## ADDENDUM 1

PROJECT NAME: FIRE STATION #24 REPLACEMENT

DATE: 07/29/2020

RFCSP: #061720DR

**C3.1**

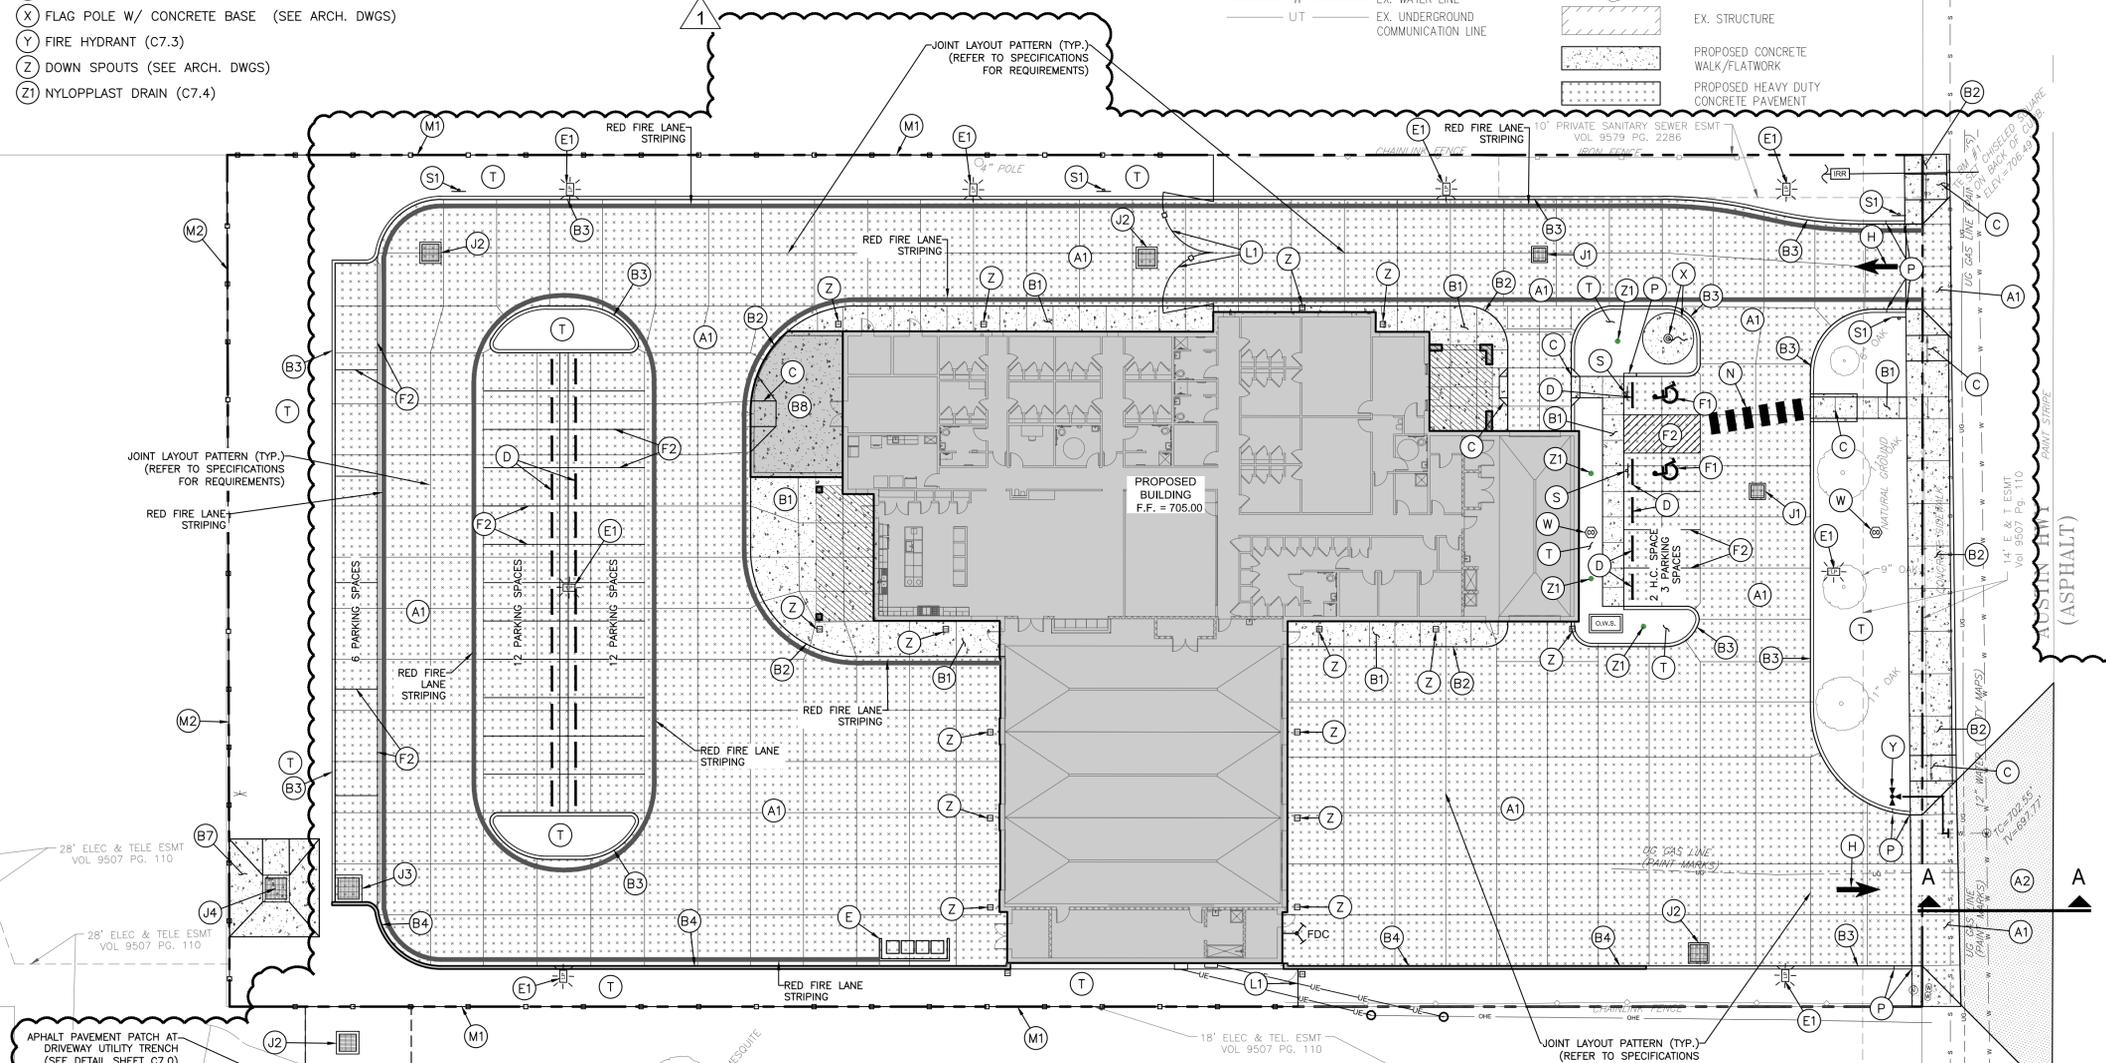
10. Sheet C3.0 Dimensional Control Plan: Replace Sheet C3.0 with the attached revised drawing. Move site plan 3'-0" towards Austin Highway and add pavement repair.
11. Sheet C3.1 Key Plan: Replace Sheet C3.1 with the attached revised drawing. Move site plan 3' feet towards Austin Highway and add pavement repair.
12. C3.1 Key Plan, Key Legend M2: Revise Fence M2 Pre-slatted fence to 8'-0" high. This applies to M2 fence locations only, not to M1 fence.
13. Sheet C4.3 Off-Site Drainage Plan: Replace C4.3 with the attached revised drawing, Revise storm drainage layout and vertical design.
14. Sheet C4.4 Off-Site Drainage Details: Replace C4.4 with the attached revised drawing. Revise details at downstream structure.
15. Sheet C7.3 Detail, Typical Pre-slatted Fence Elevation / Section: Revise to 8'-0" height where Fence Type M2 is noted on the Key Plan Sheet C3.1.

REVISIONS
7/22/20 ADDENDUM 1
SHIFTED SITE PLAN 3' SOUTH & ADDED PVMT. REPAIR AREA
PROJECT NO. 118037
PHASE 100% CONSTRUCTION DOCUMENTS
DATE APRIL 2020
DESCRIPTION KEY NOTE PLAN

**C4.3**

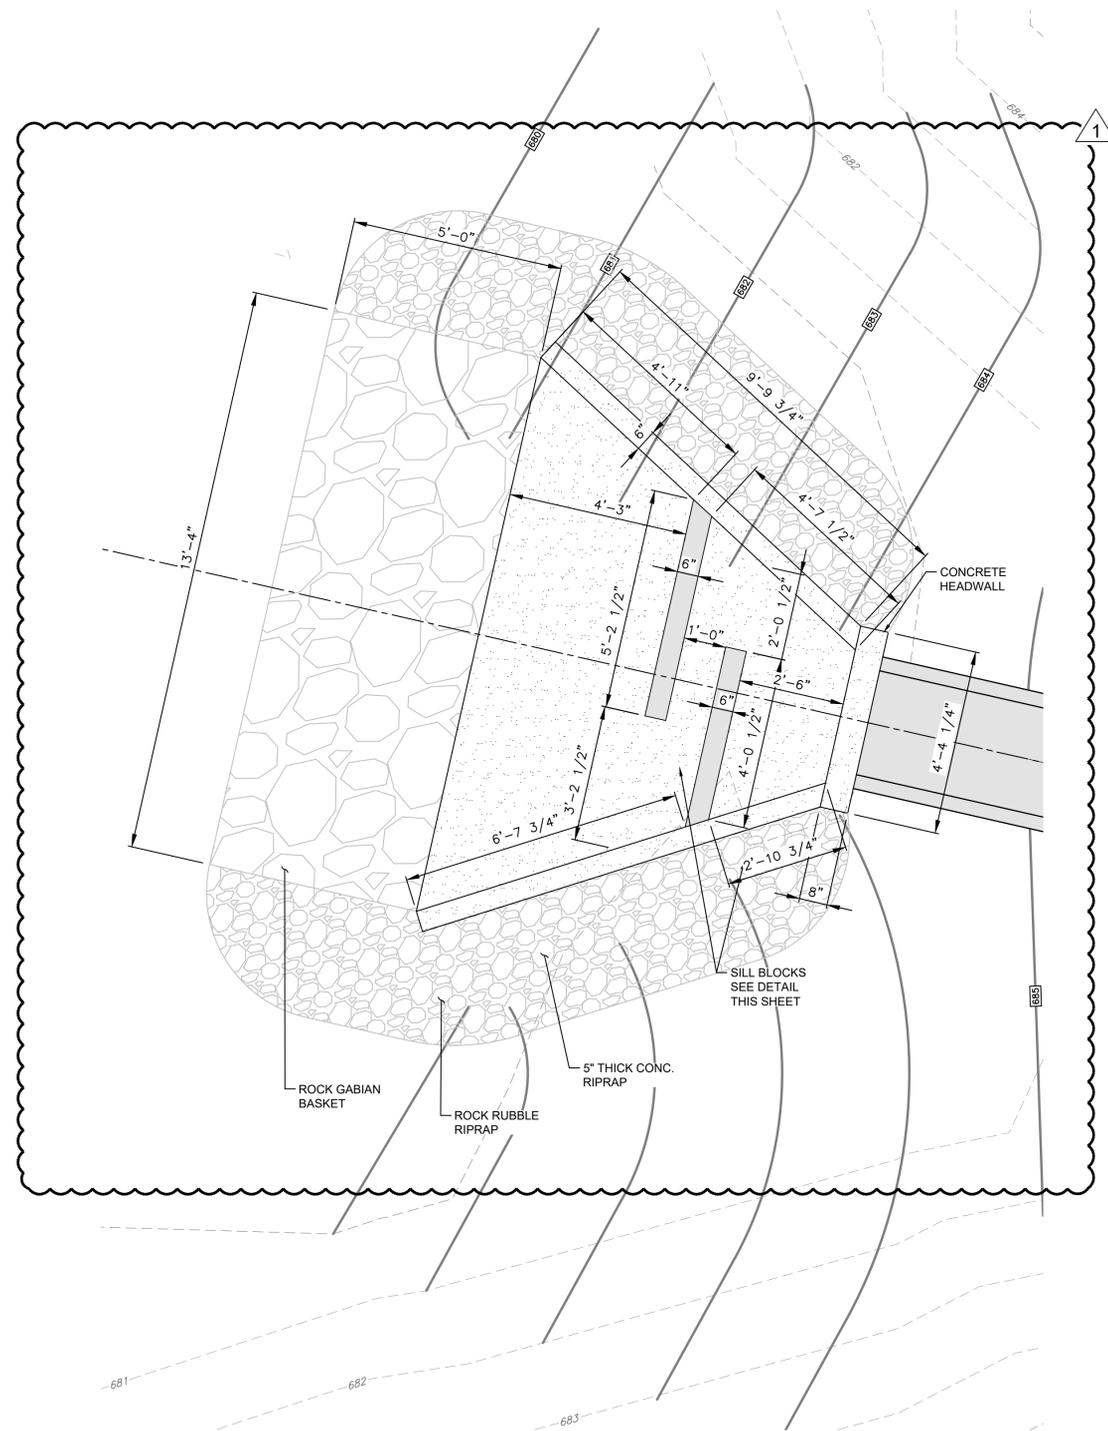
7/22/20	ADDENDUM 1
REVISED STORM DRAIN LAYOUT AND VERTICAL DESIGN

A4.01

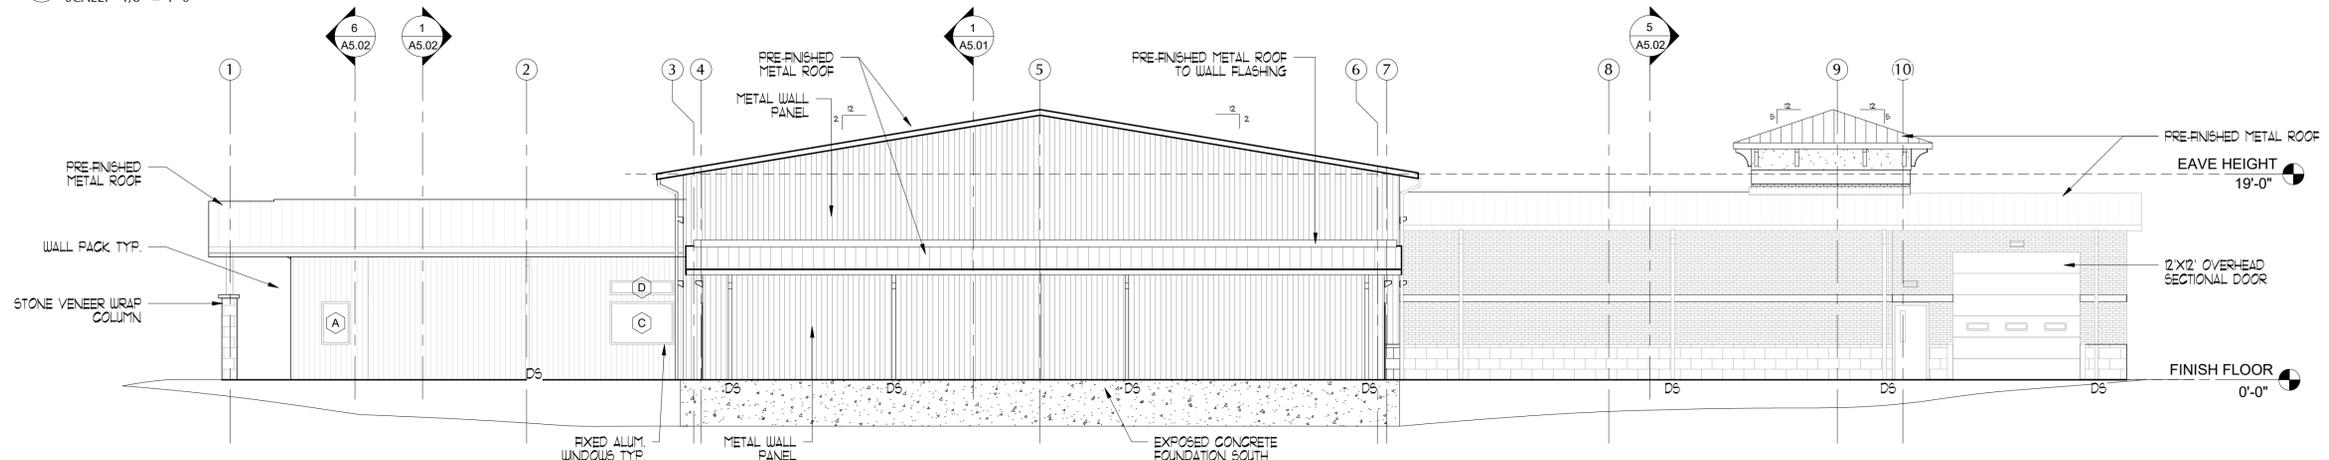
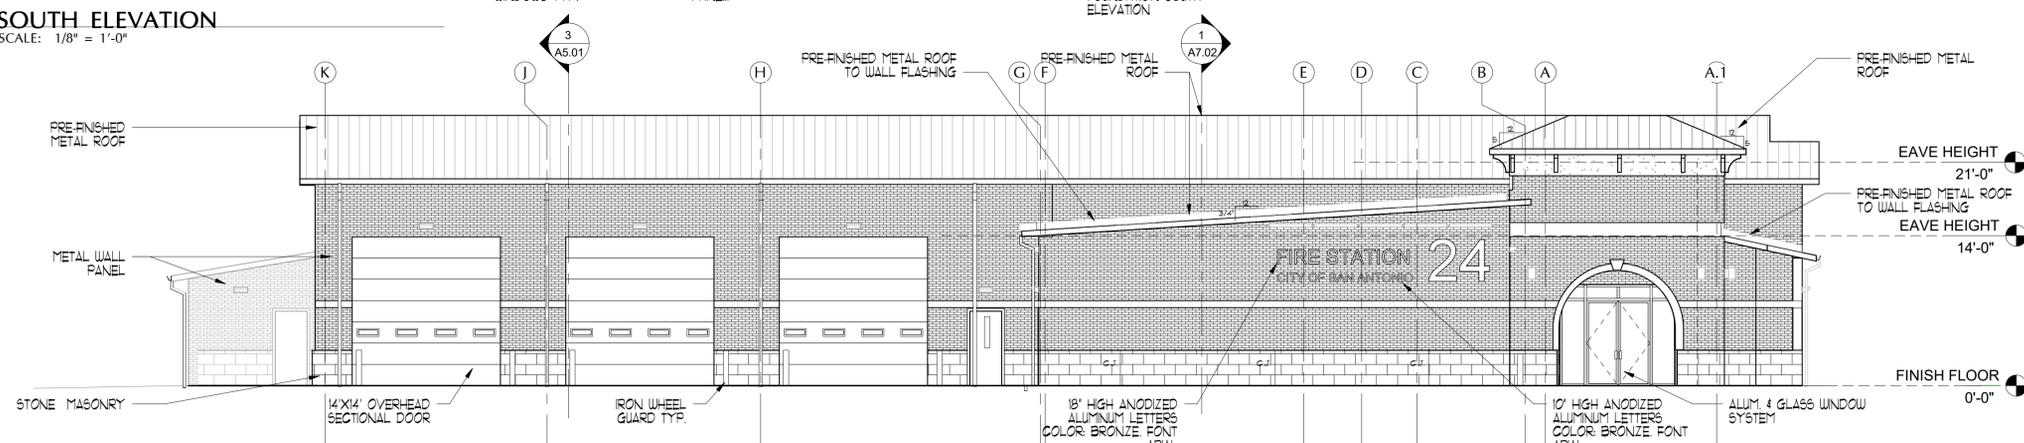
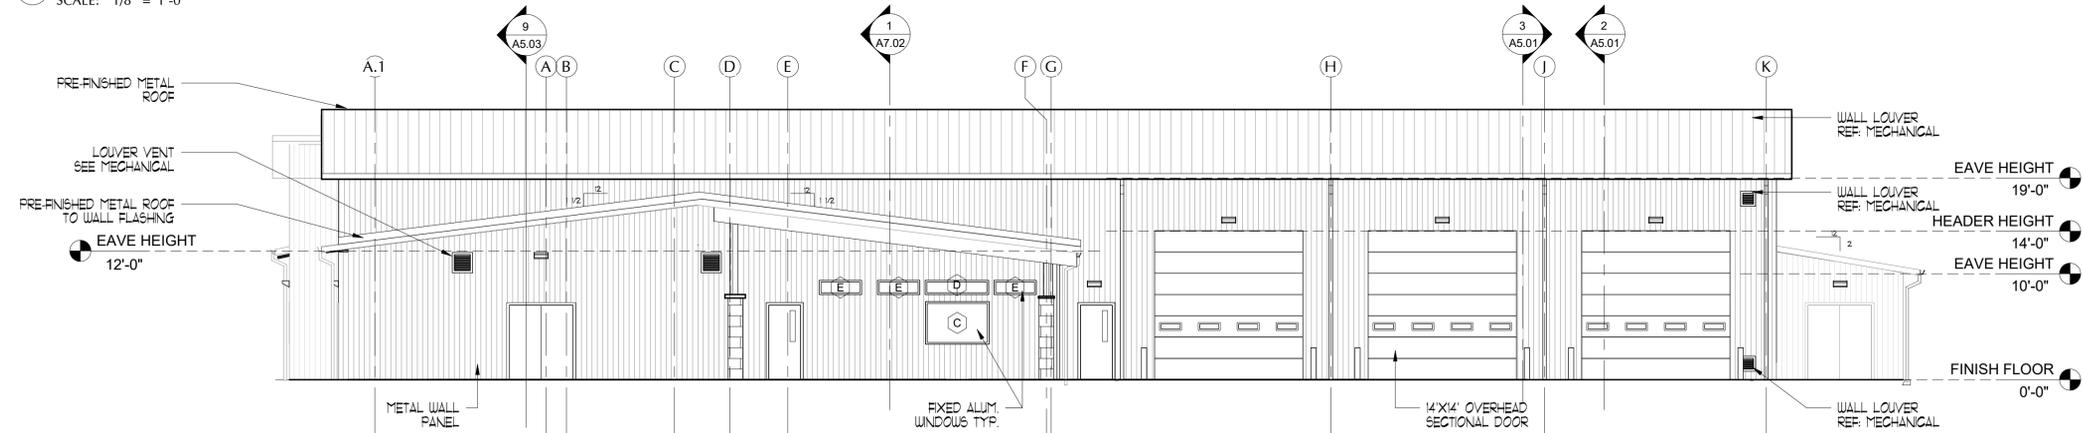
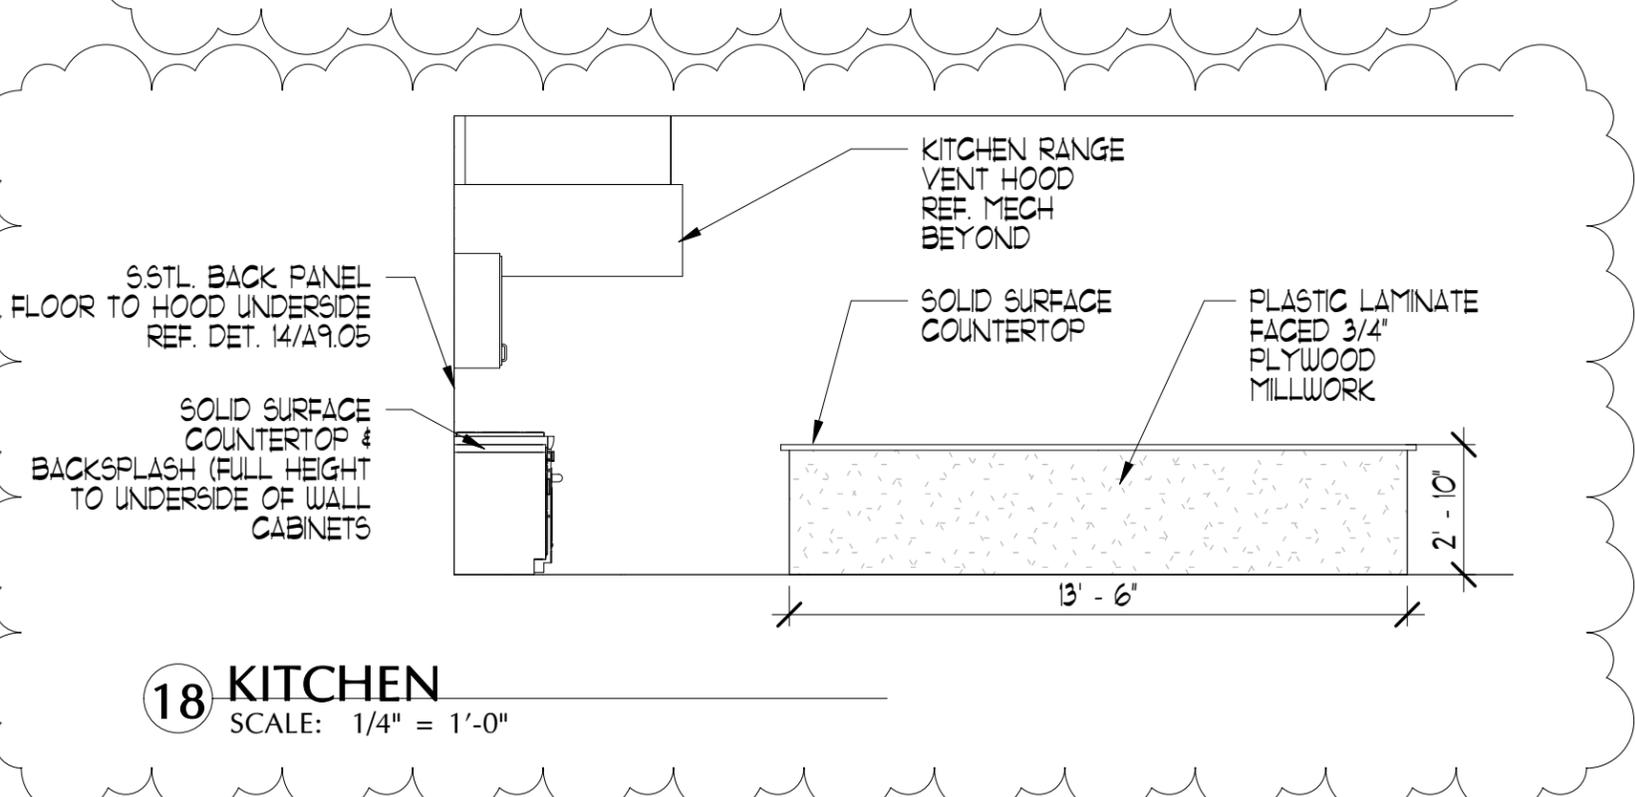
19. Sheet A4.01, Exterior Elevations – Revise East Elevation and a portion of the North and South Elevations per the attached revised A4.01. Elevations fronting Austin Highway to be stone and brick masonry with stucco in the base bid. The West Elevation and the primary portions of the North and South Elevations to remain metal wall panel in the base bid. The Bid Alternate will replace the metal wall panel on these three elevations with stone, brick and stucco as shown in the A10 series drawings.

**1 ENLARGED LAUNDRY PLAN**  
SCALE: 1/4" = 1'-0"

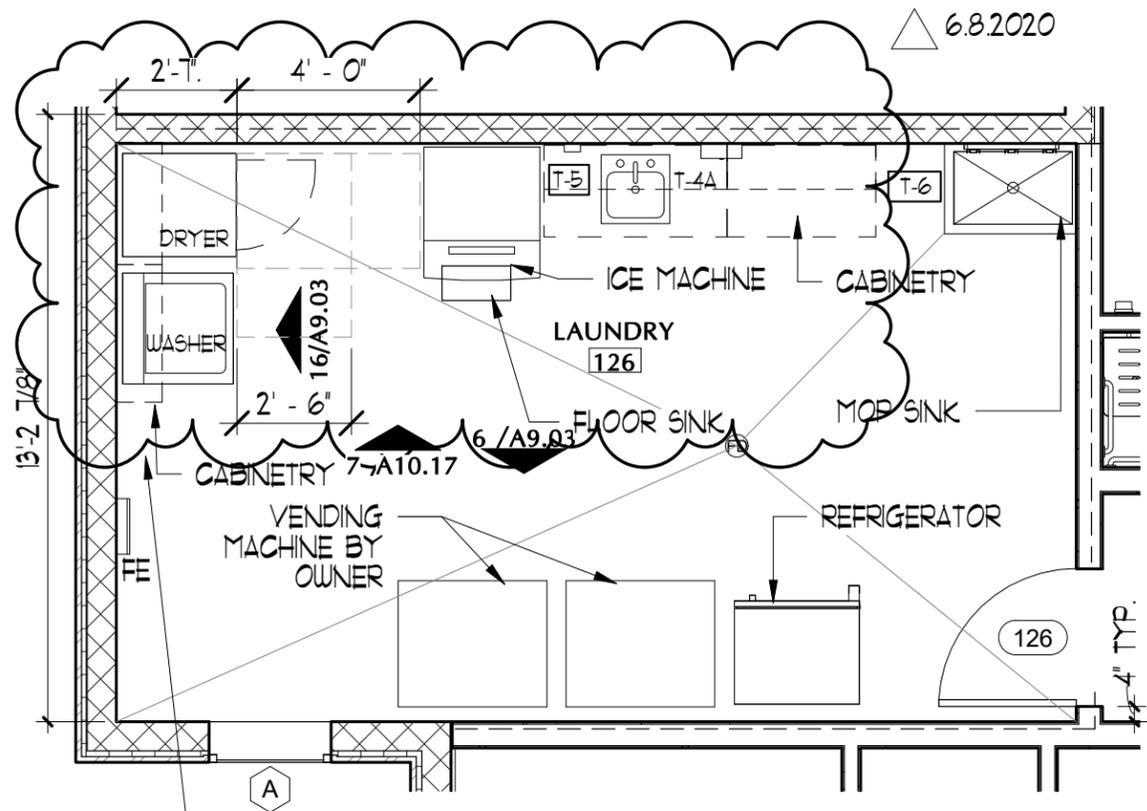
20. Sheet A9.01 Enlarged Floor Plans – Revise Enlarged Plans 1, 2 and 6 per the attached. Add Interior Elevation of Kitchen Island east side per the attached. Toilet Accessory Clarification: Recessed paper towel dispensers shall be installed where indicated at metal stud wall locations. Surface mounted paper towel dispensers shall be installed at all masonry wall locations.

AMENDMENT # 6.8.2020 - ICE MACHINE AND WALL MOUNTED PAPER TOWEL DISPENSER RELOCATED ALONG CABINET/COUNTER PROVIDING 30"X48" CLEAR FLOOR SPACE FOR WASHER AND DRYER

**2 ENLARGED BATH PLAN**  
SCALE: 1/4" = 1'-0"

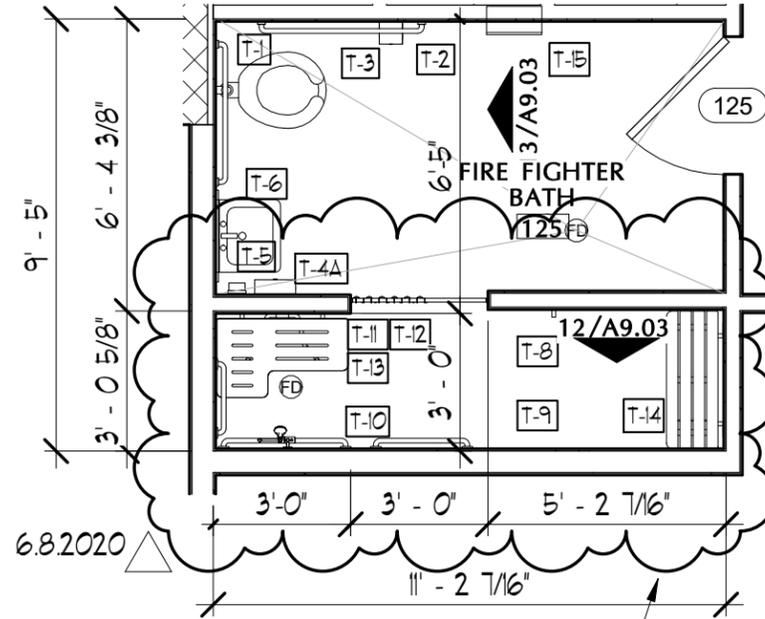
AMENDMENT # 6.8.2020 - SHOWER CONTROL RELOCATED TO OPPOSITE SIDE OF SEAT ENTRY WIDTH 36" WIDE ADJACENT TO A CLEAR INSIDE DIMENSIONS 36"X36" SHOWER REVISED LOCATION OF ACCESSIBLE BENCH

**4 KITCHEN**  
SCALE: 1/4" = 1'-0"

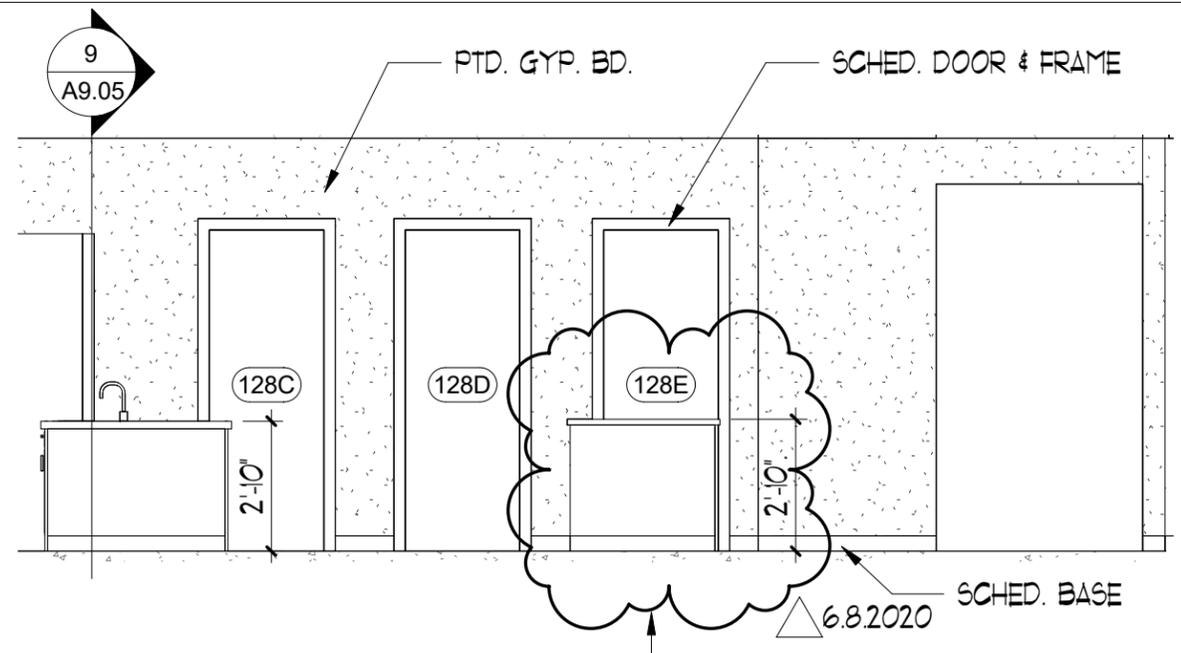
AMENDMENT # 6.8.2020 - OMIT CABINETRY AND PROVIDE KNEE SPACE 27" MIN. CLEARANCE  
OPENING BELOW COUNTER FOR GARBAGE CANS
